**PLANNING COMMISSION**  
**APPEAL OF ADMINISTRATIVE DENIAL OF A WAIVER OF DESIGN GUIDELINES**

**CASE NUMBER:** SP-2022-0218C.SH      **PC DATE:** March 11, 2025

**PROJECT NAME:** Avalon Pointe

**ADDRESS:** 2610 Hume Place  
**COUNCIL DISTRICT:** 9  
**NEIGHBORHOOD PLAN:** Central Austin Combined

## FIRST FLOOR PLAN

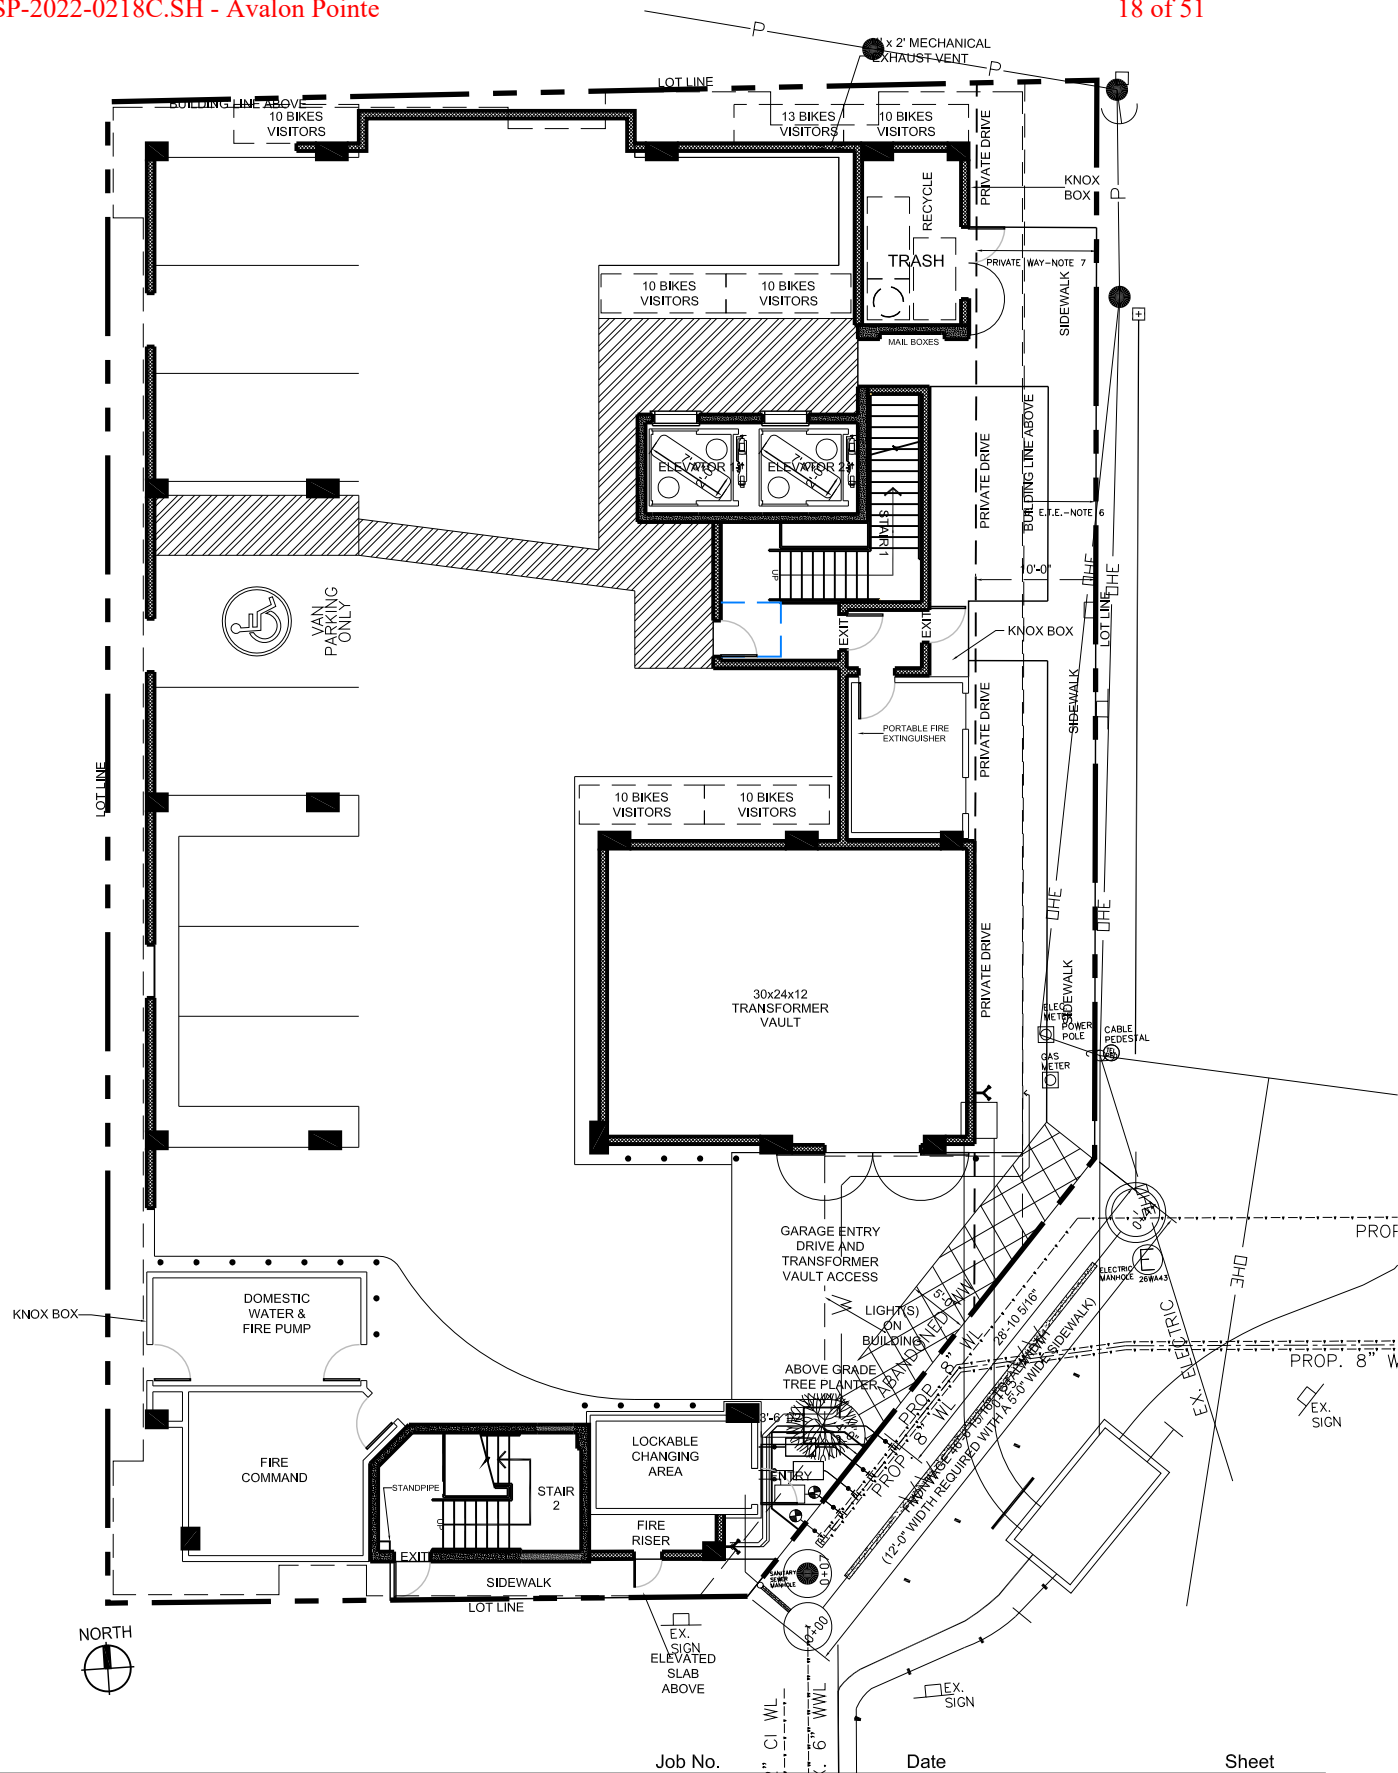
**2. Explanation of Why the Provision Is Unreasonable or Impractical as Applied to the Site Plan:**

Despite the requested waiver, the site plan will continue to substantially comply with the design guidelines by:

Attached are site plan exhibits that illustrate the proposed lighting placements and demonstrate how the project will continue to meet the spirit and intent of the design guidelines.

## FIRST FLOOR PLAN

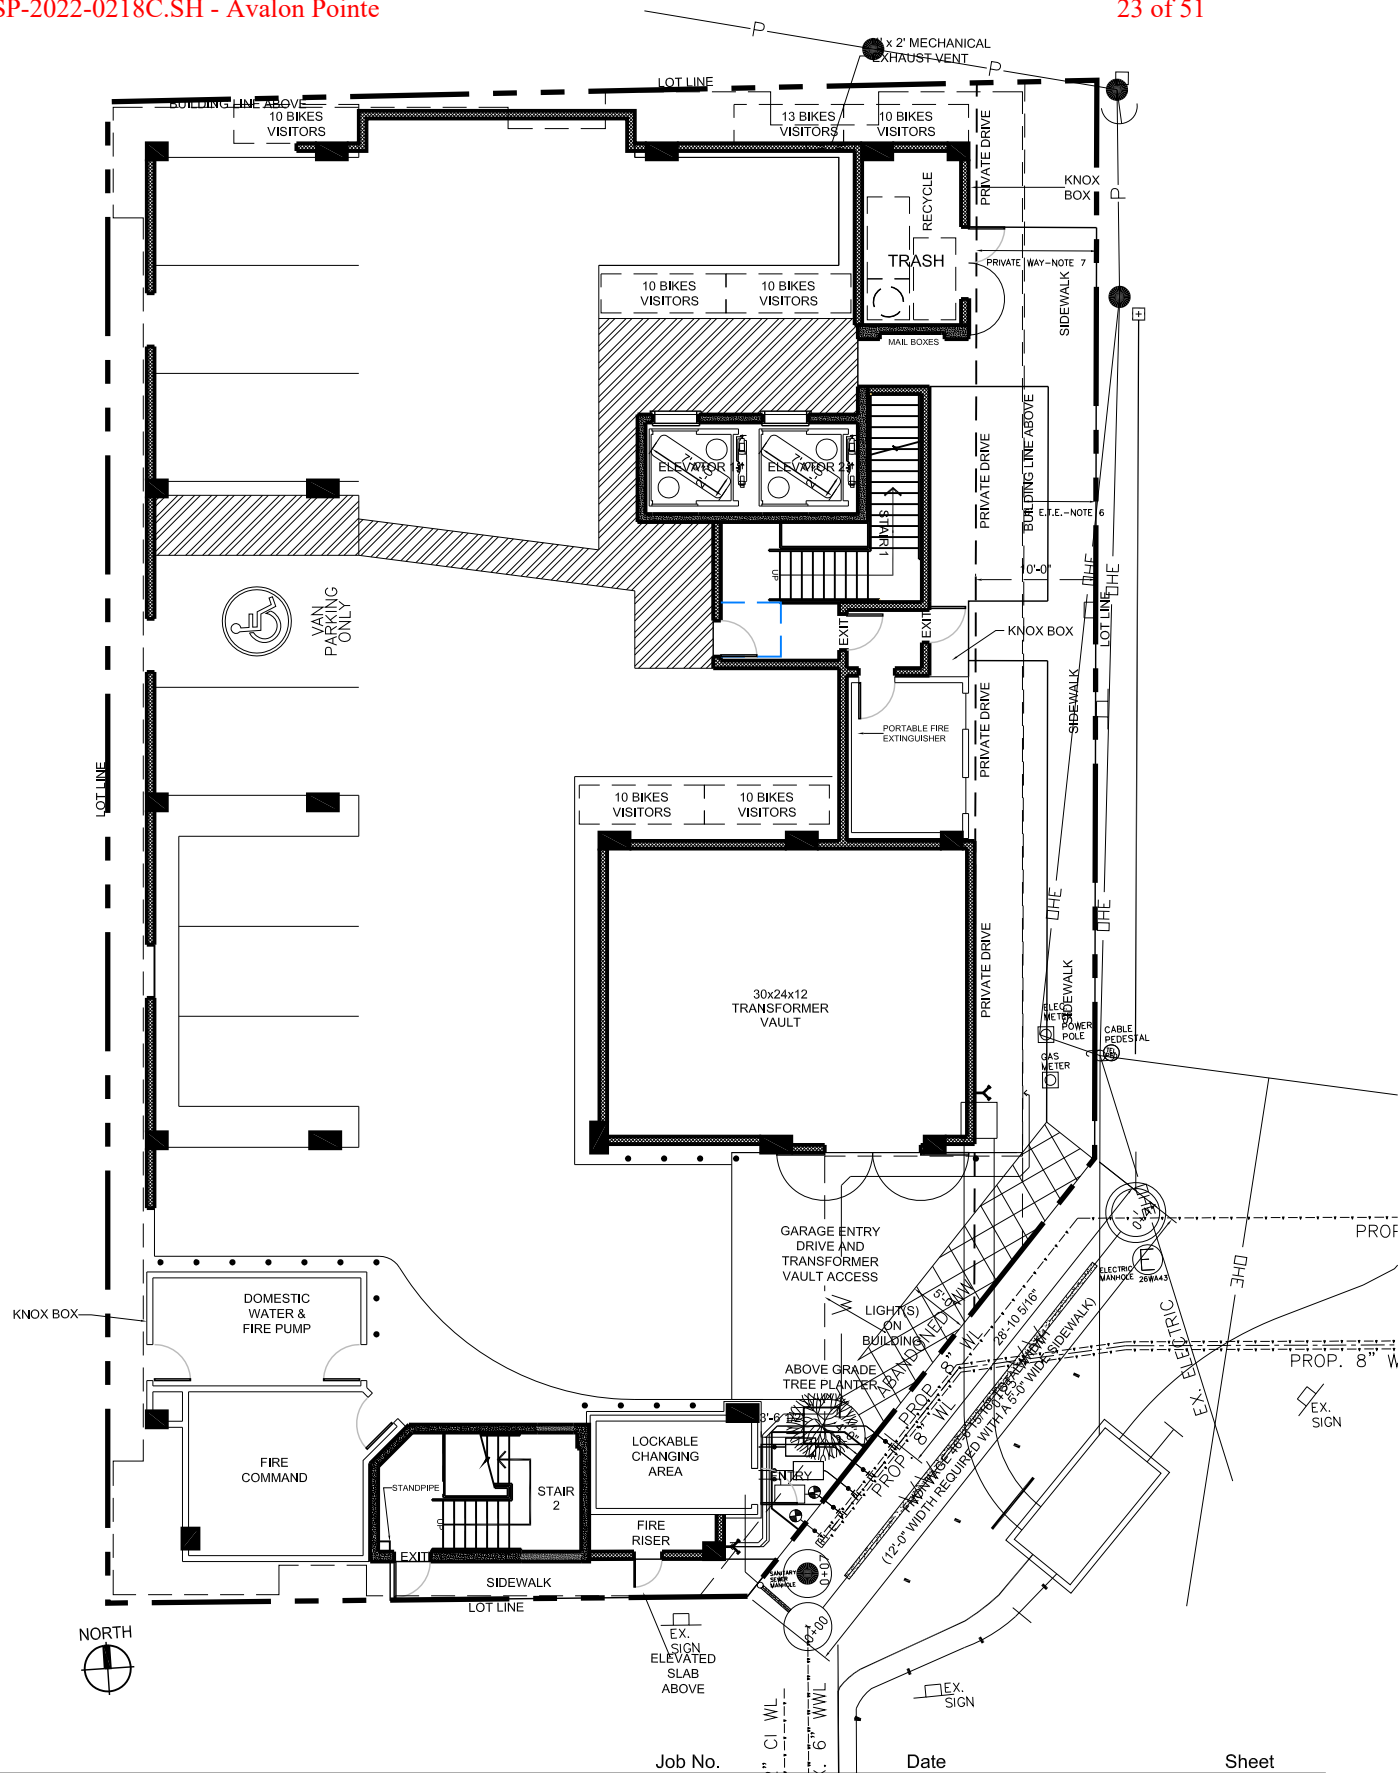
We are requesting a waiver from Provision 12.1.7.I(g), which requires a minimum pedestrian clear zone width of 5 feet between the edge of a tree grate/planting bed and any walls/planters or other vertical elements associated with development (as per COA Detail 710S-6A). In cases where above-grade planters are used, a minimum clear zone of 6 feet is required (as per COA Detail 432S-7D).

**2. Explanation of Why the Provision Is Unreasonable or Impractical as Applied to the Site Plan:**

Attached are relevant site plan exhibits that illustrate the proposed adjustments and demonstrate continued compliance with the overall design intent.

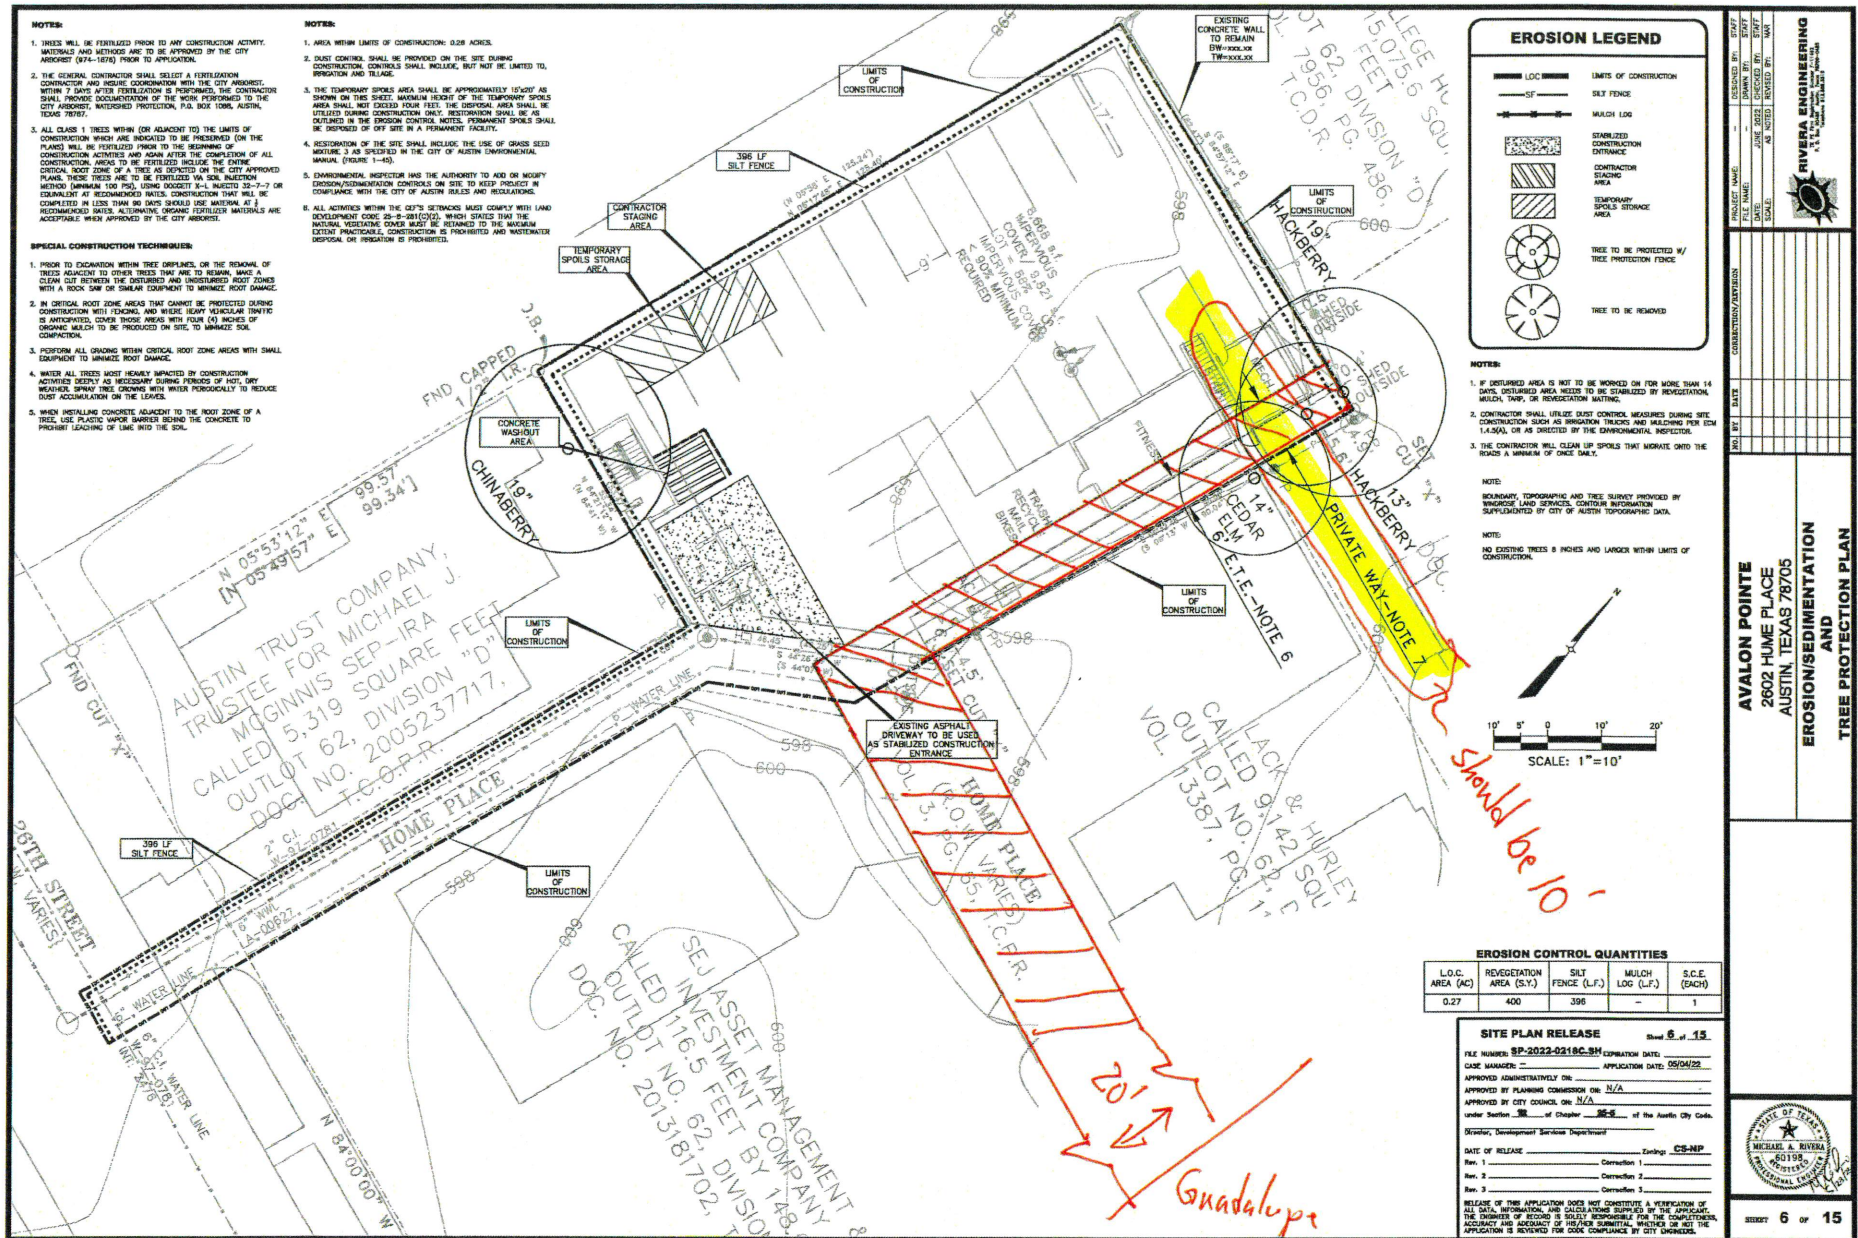
Missing from their later submittals. Why? How?

January 2024 Where did the "Private Way" go? (Recorded in Vol. 261 Page 410)
